September 11, 2009  
NND-09-0266

Subject: Virgil C. Summer Nuclear Station (VCSNS) Units 2 and 3 Combined License Application (COLA) - Docket Numbers 52-027 and 52-028 Supplemental Response to NRC Request for Additional Information (RAI) Letter No. 060

**NRC RAI Number: 02.05.02-27**

Figure RAI 2.5.2-27.1

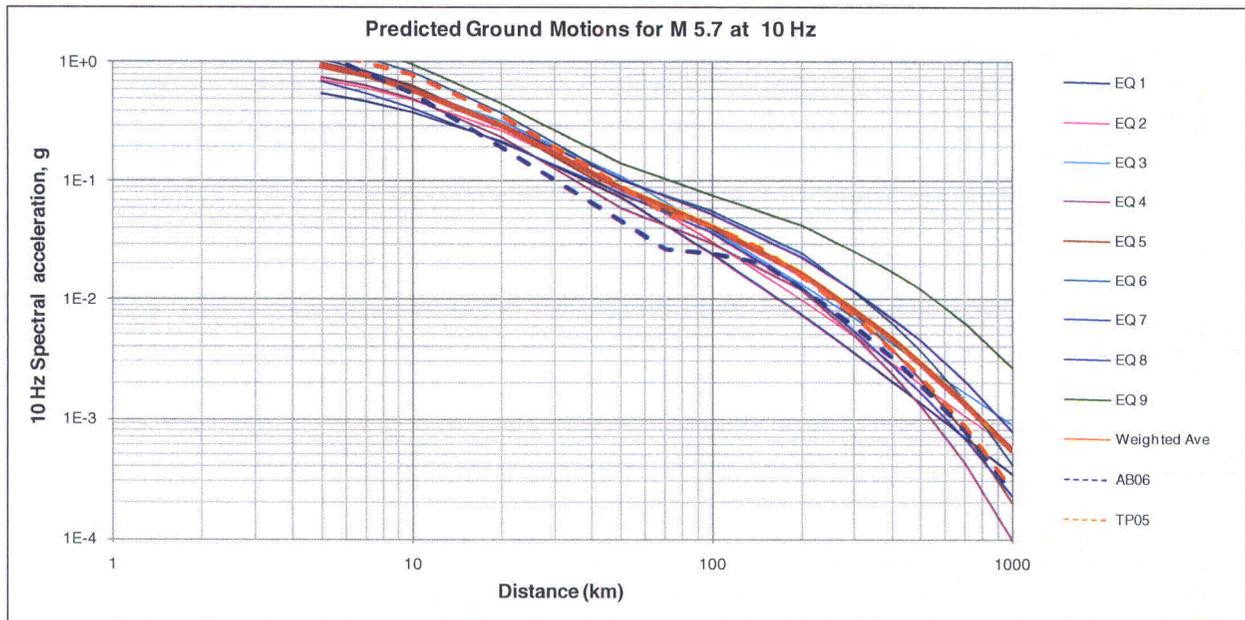
The staff reviewed your response to RAI 2.5.2-14. However, the figures provided by you in your response (i.e. Figure RAI-14A and RAI-14B) are difficult to read. Please provide electronic versions of the data used to plot these figures in order for the staff to verify your conclusions that the two more recent equations, published since the EPRI (2004) study, are consistent with the EPRI (2004) study. In addition, please clarify whether the “weighted average” of Equations 1 through 12 in RAI response Figure RAI-14A and RAI-14B reflects the actual weights of these equations as represented in the EPRI 2004 ground motion model (i.e. ground motion model clusters, individual models, and weights recommended when multiple source types are used for hazard calculations) or whether it reflects an equally weighted average. If an equally weighted average was used, please provide justification for not using the actual EPRI weights. Furthermore, in Figure RAI-14B, which plots predicted ground motions for  $M=5.7$ , the EPRI models EQ10, EQ11, and EQ12 should not be included because they are only for earthquakes with magnitudes larger than 6.0.

In your response, you provided a plot of ground motion amplitudes for 1 Hz spectral acceleration for  $M=7$  earthquakes versus distance for the 12 equations used from EPRI (2004), and for the Tavakoli and Pezishk (2005) and Atkinson and Boore (2006) references (i.e. Figure RAI-14A). You also provided a plot of ground motion amplitudes for 10 Hz spectral acceleration for  $M=5.7$  (i.e. Figure RAI-14B). Since FSAR Table 2.5.2-218 shows that the controlling earthquakes for the VCSNS site range from  $M 6.1$  to  $7.3$ , please also provide additional plots for  $M=5.2$ ,  $6.1$ , and  $7.3$  in addition to those provided in response to RAI 2.5.2-14. You also stated in your response that the Petersen et al. (2008) ground motion model, which was used in the latest version of the USGS National Seismic Hazard Maps, does not constitute an independent ground motion model because it involves a weighting of many of the equations used in the EPRI (2004). However, it is the weights, not the particular set of models, that are crucial in determining the particular ground-motion values (as they are in the EPRI 2004 model). Therefore, please provide further justification for not considering the Peterson et al. (2008) model as a separate and new ground-motion model.

Electronic versions of the data plotted in VCSNS Figures RAI-14A and RAI-14B are contained in text file RAI14\_figures\_data.txt. The “weighted average” curve uses the weights given in Figure 5-3 of EPRI (2004) for the 12 equations for “non-general area sources,” not equal weights. Figure RAI 2.5.2-27.1 below re-plots the equations for M 5.7, 10 Hz, using the 9 “general area source” equations from EPRI (2004), and for this plot, the “weighted average” curve uses the weights given in Figure 5-2 of EPRI (2004) for the 9 equations for “general area sources.” In this plot the Atkinson and Boore (2006) (AB06) and Tavakoli and Pezeshk (2005) (TP05) equations are shown as thick dashed lines. It is noted that EPRI (2004) recommends that the 12 “non-general area source” equations be used for sources where magnitudes >6.0 are the dominant contributors to ground motion, and smaller magnitudes within that same source should use the same 12 equations.

Figure RAI 2.5.2-27.8

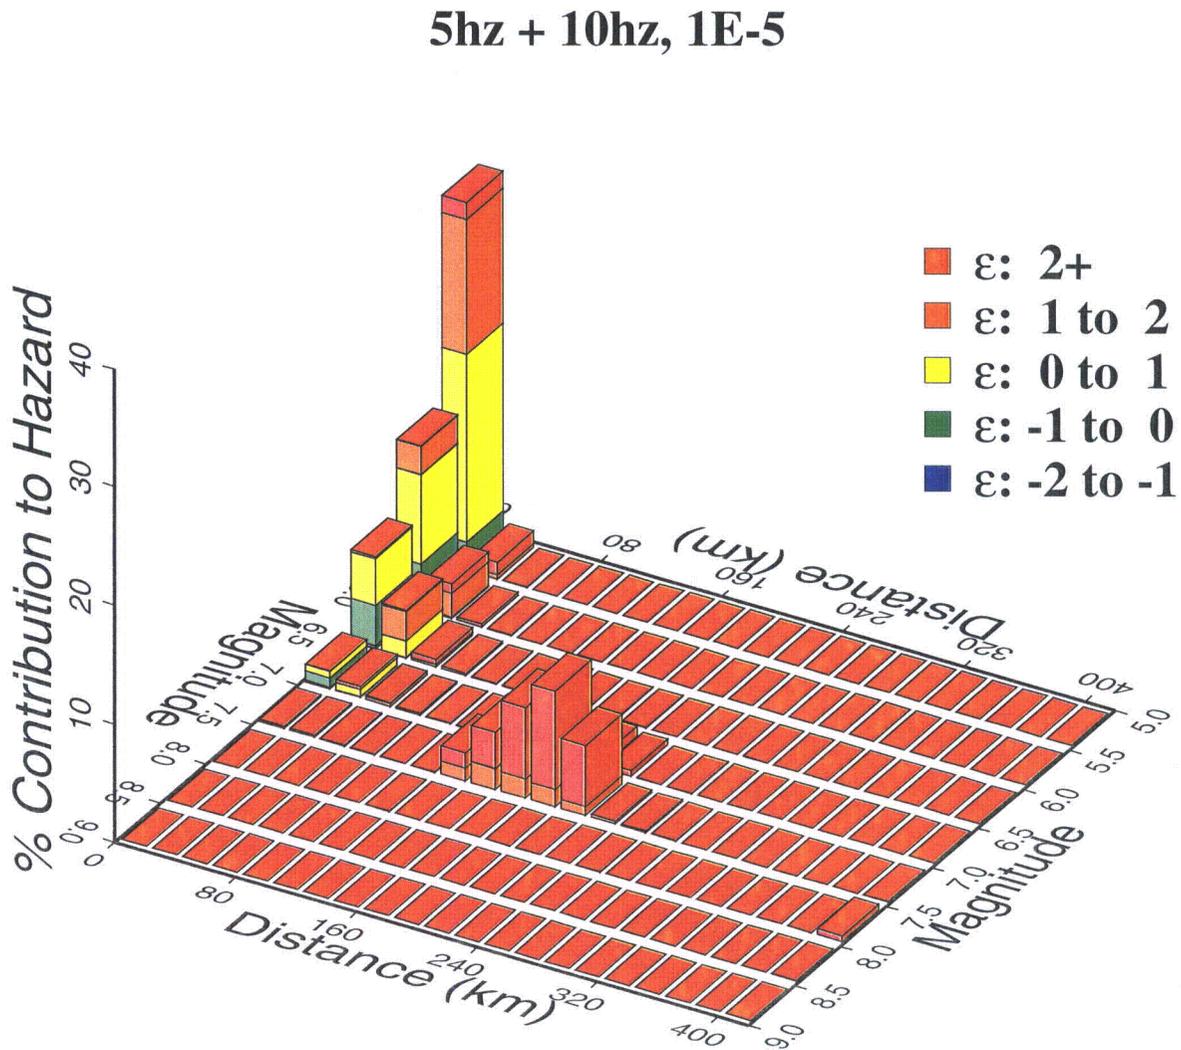
In addition, please explain why the controlling earthquake for 5 and 10 Hz at  $10^{-5}$  annual frequency of exceedance is not  $M \sim 5.0$  to  $5.5$  at a distance of approximately 0 to 20 km (i.e. based on FSAR Figure 2.5.2-239), instead of  $M 6.1$  at 70 km as listed in FSAR Table 2.5.2-218? FSAR Figure 2.5.2-239 shows that small, local earthquakes dominate the high frequency, and also that some contribution also occurs for low frequency motions from large, distant earthquakes in the Charleston SC region (i.e. closest distance to the Charleston seismic source zone is slightly greater than 100 km).

Regarding the 5 Hz and 10 Hz deaggregation at  $10^{-5}$ , several changes have been made to this deaggregation. First, the hazard changed slightly as a result of more accurate assumptions made about magnitudes below 5.0 with the CAV filter, which modified the  $10^{-5}$  UHRS values slightly. Second, the calculation of mean distance was made using the exponent of the average logarithmic distance, which is recommended in Regulatory Guide 1.208, rather than using the mean arithmetic distance. A deaggregation plot is included below as Figure RAI 2.5.2-27.8. As a result of these changes, the mean magnitude and distance for this deaggregation are 6.2 and 31 km. The mean

magnitude is 6.2 rather than 5.0 to 5.5 because the contributions by magnitude, while showing a mode in the range of 5.0 to 5.5, have a long tail, with contributions as high as M 7.0 to 7.5. (Figure RAI 2.5.2-27.8 also shows a very small contribution from higher magnitudes coming from the New Madrid seismic zone.) The mean magnitude of this highly skewed distribution is 6.2. Also, the contributions by distance, while having a mode in the range 0 to 20 km, have a long tail, with contributions as far as 200 to 220 km. (Figure RAI 2.5.2-27.8 also shows a very small contribution from longer distances coming from the New Madrid seismic zone.) The logarithmic mean of this highly skewed distance distribution is 31 km. The VCSNS FSAR will be updated to reflect the revised mean magnitudes and distances.

VCSNS FSAR Figure 2.5.2-239 will be updated to reflect the revised mean magnitudes and distances shown in Figure RAI 2.5.2-27.8 in the next VCSNS FSAR revision.
